# Technical Service Bulletin

## 01 MIL on and/or oil pressure warning on (DTC P164D00)

01 15 27 2041093/1 June 30, 2015.

Model(s)	Year	VIN Range	Vehicle-Specific Equipment
A6, A7	2016	All	3.0 TFSI EVO
A8	2015 - 2016	All	3.0 TFSI EVO

**Figure 1.** Correct and incorrect position of the oil drain plug.

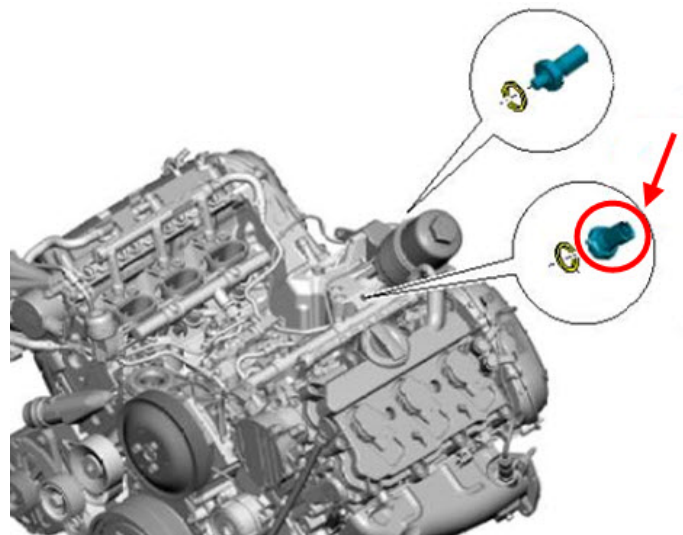
Rubber oil drain plug within the oil filter housing is out of position.

- **If oil pressure is below 1.3 bar:**  
Open the oil filter housing to check the rubber oil drain plug. If the plug is not positioned correctly in the spring (Figure 1), replace the plug.
- **If oil pressure is above 1.3 bar:**  
Replace the low pressure oil pressure sensor F378 (Figure 2).

Improved rubber plug.
